October 12, 2016

MODENA STREET (HARRISON TO SPRING) SIDEWALK

Addendum #1

SHEET X-1

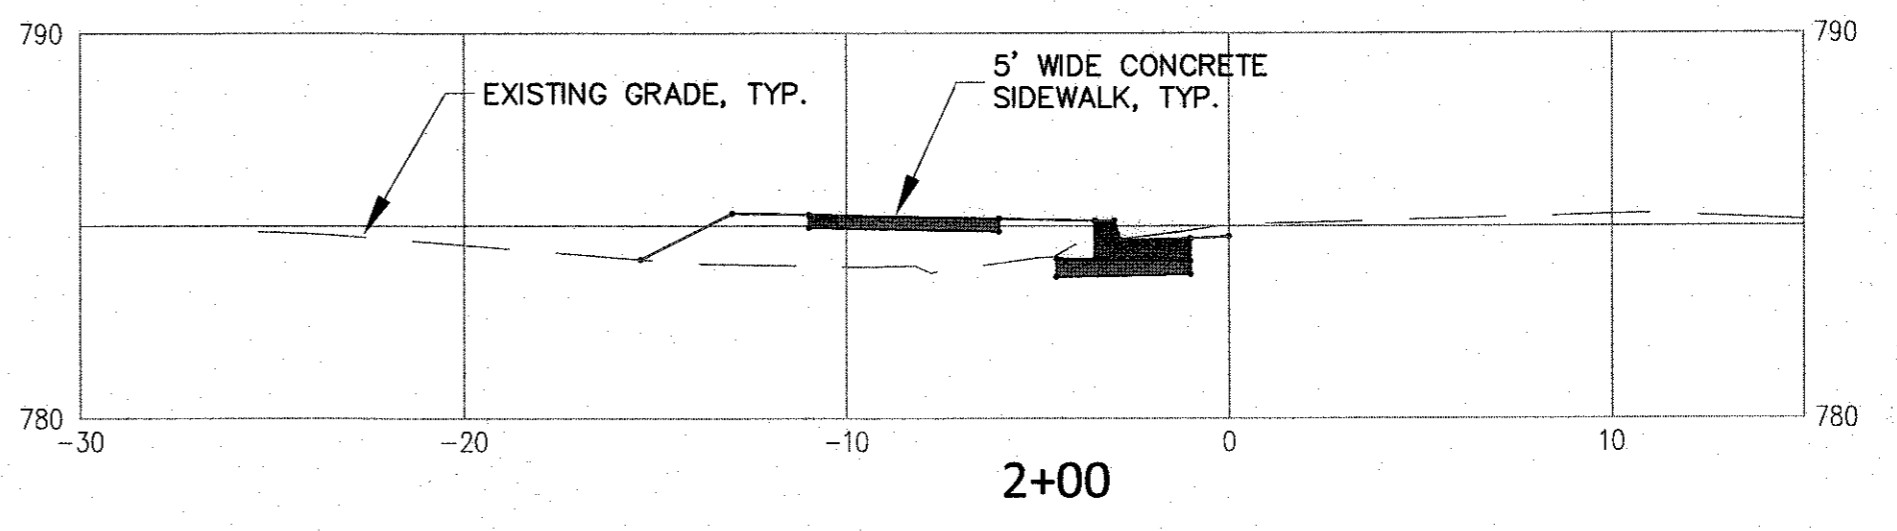
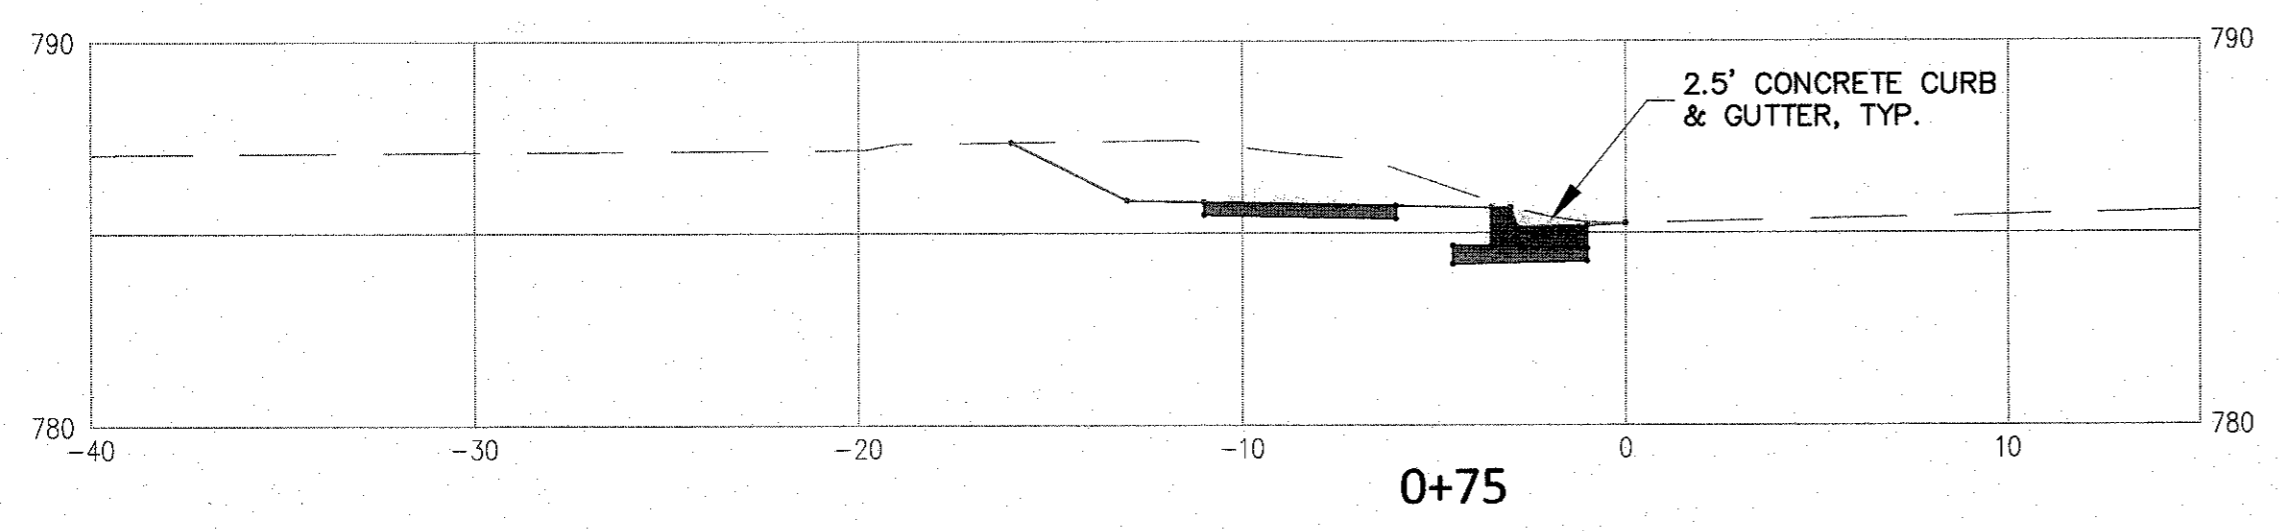
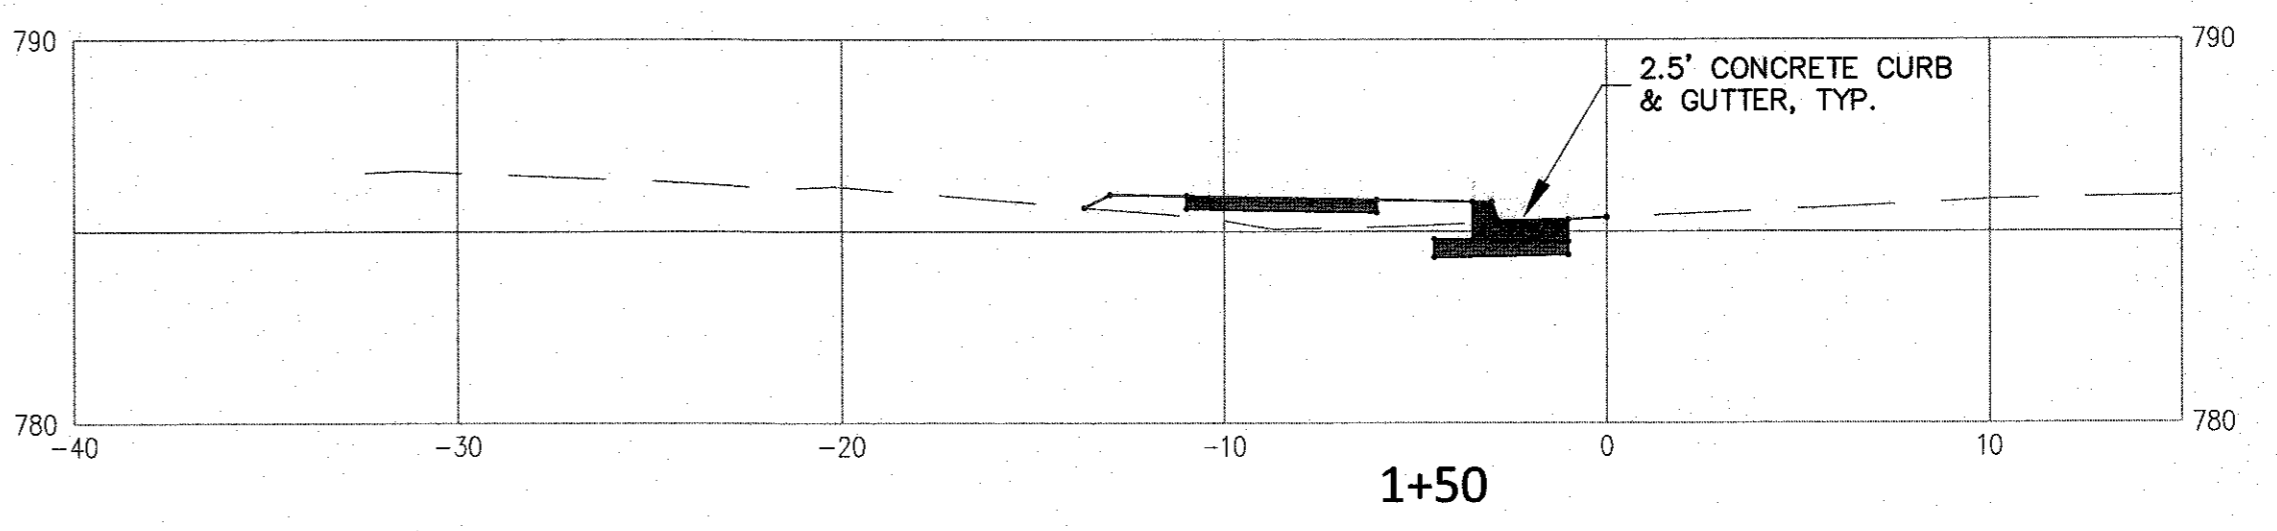
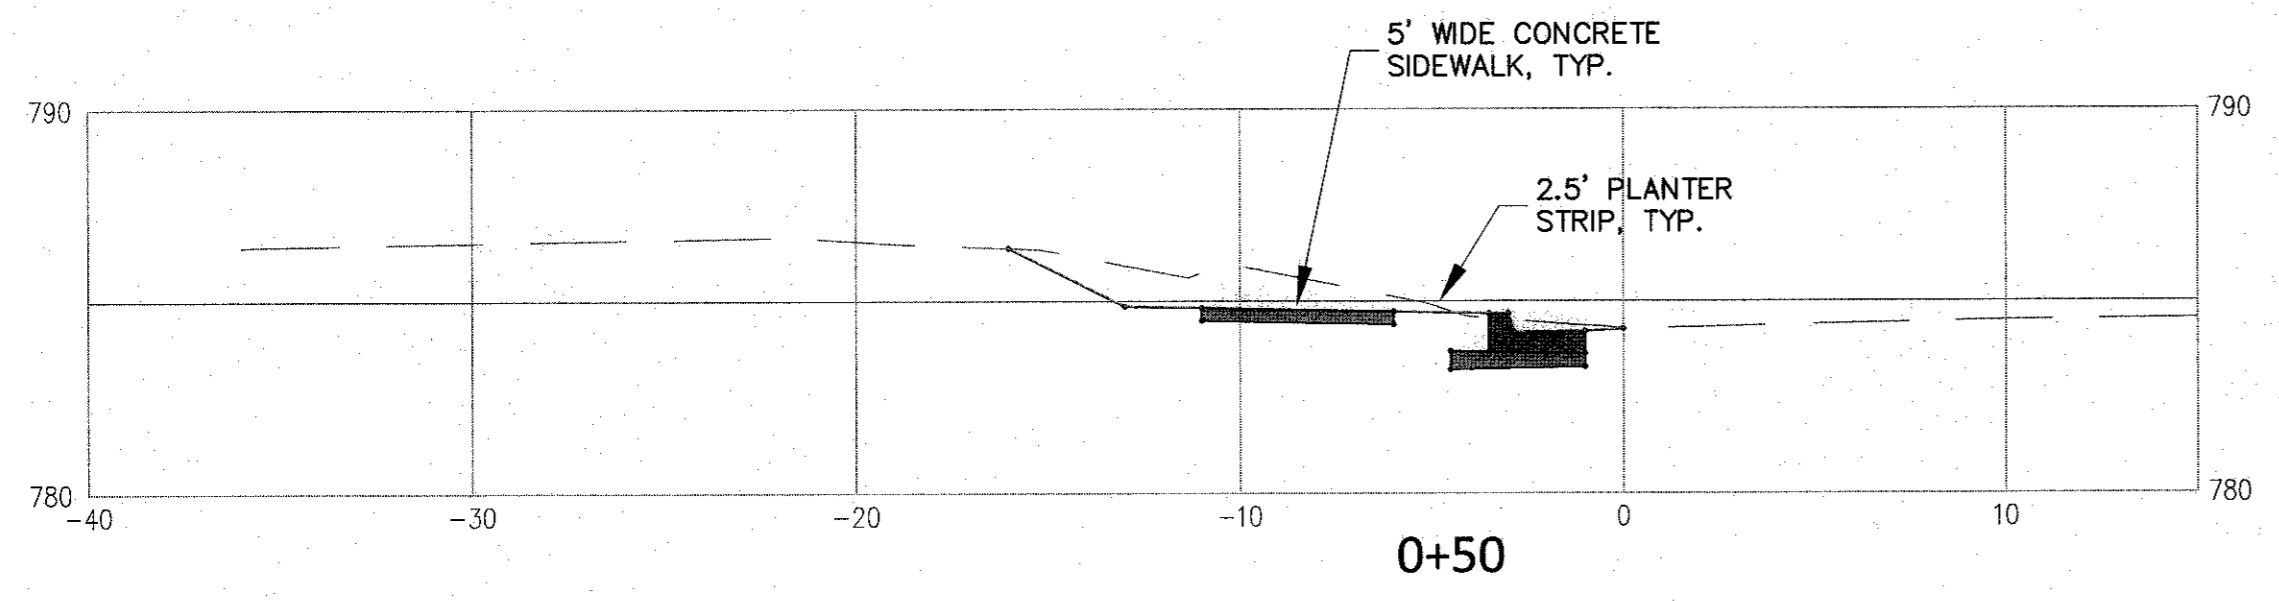
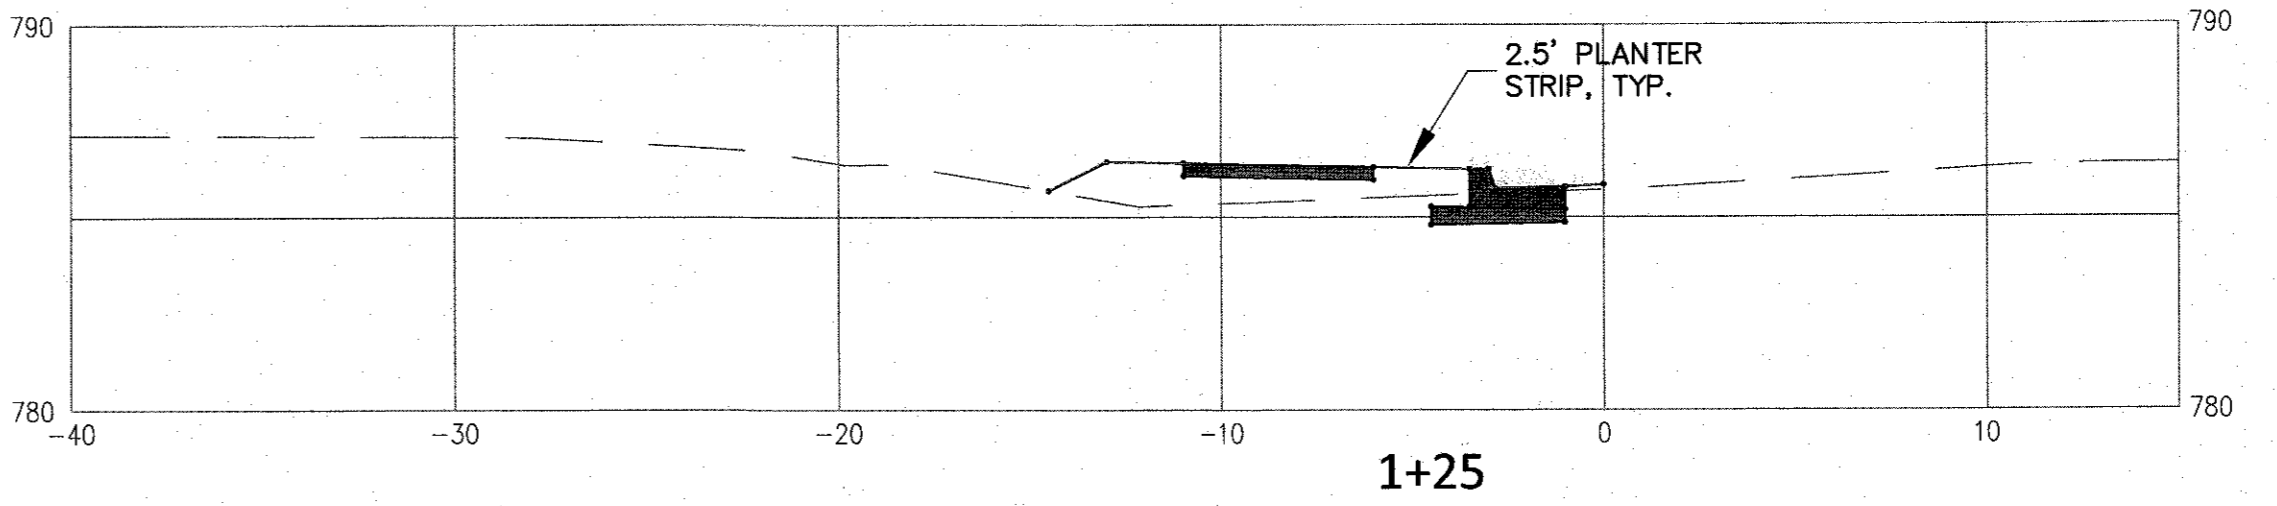
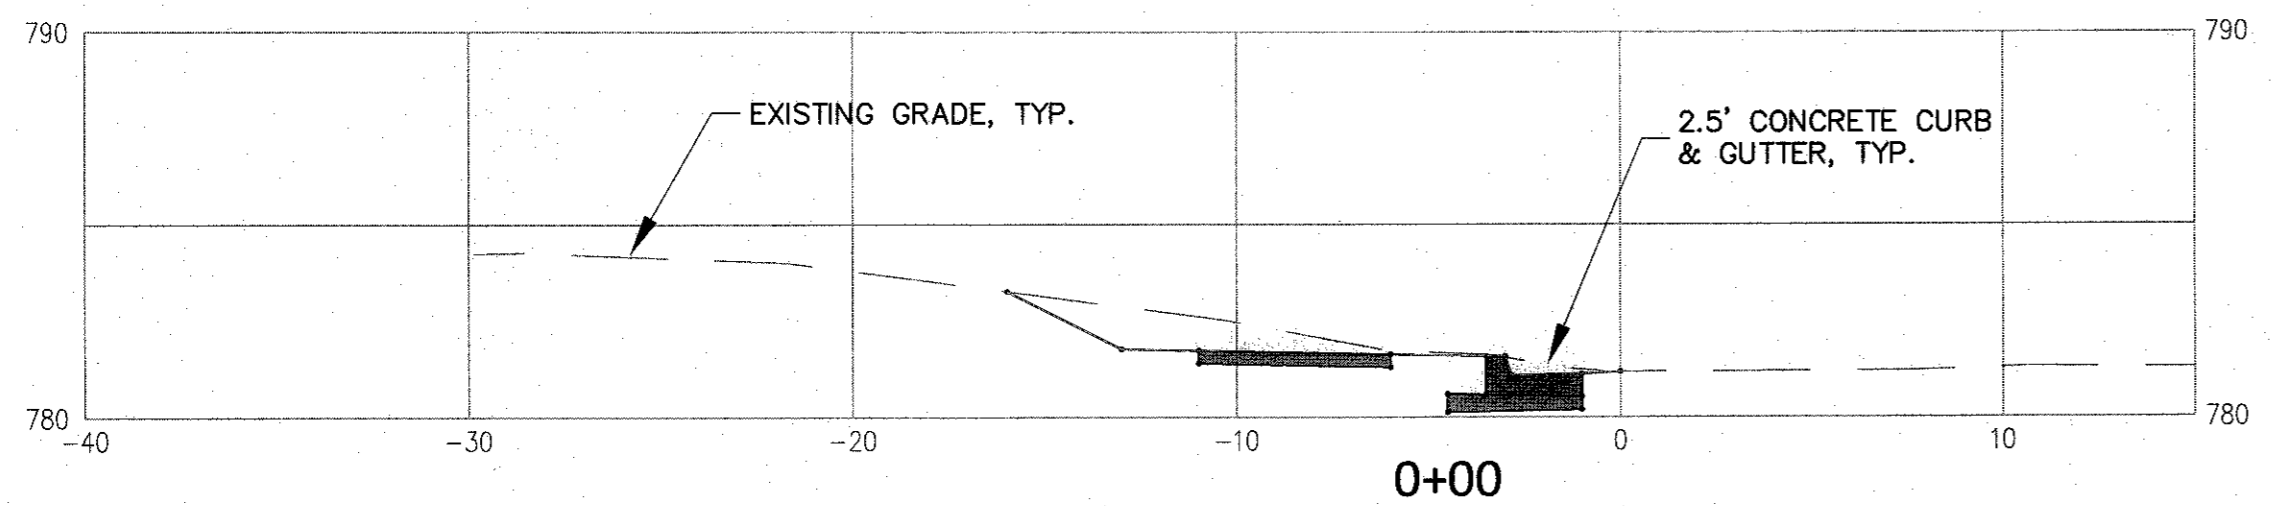
- Additional cross sections for proposed sidewalk from Sta. 0+00 to 9+00 and 13+50 to 16+09. (X-1 thru X-5) are attached to this Addendum. If you have already picked up your bid documents and plans, and would prefer a hard copy of the revised sheets, please contact caryr@cityofgastonia.com.
